#### Regulation No. 94 (Frontal collision)

## Proposal for the 03 series of amendments

### Submitted by the expert from France\*

Model A

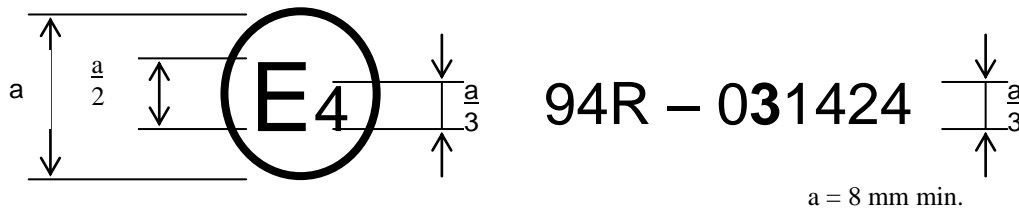
The above approval mark ... Regulation No. 94 under approval number 031424. The approval number ... Regulation No. 94 as amended by the 03 series of amendments.

Model B

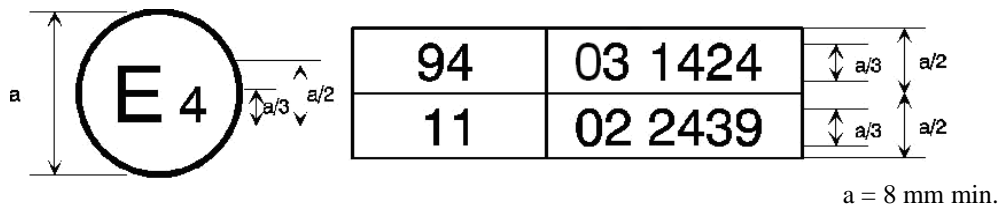
The above approval mark ... Regulation No. 94 incorporated the 03 series of amendments and Regulation No. 11 incorporated the 02 series of amendments."
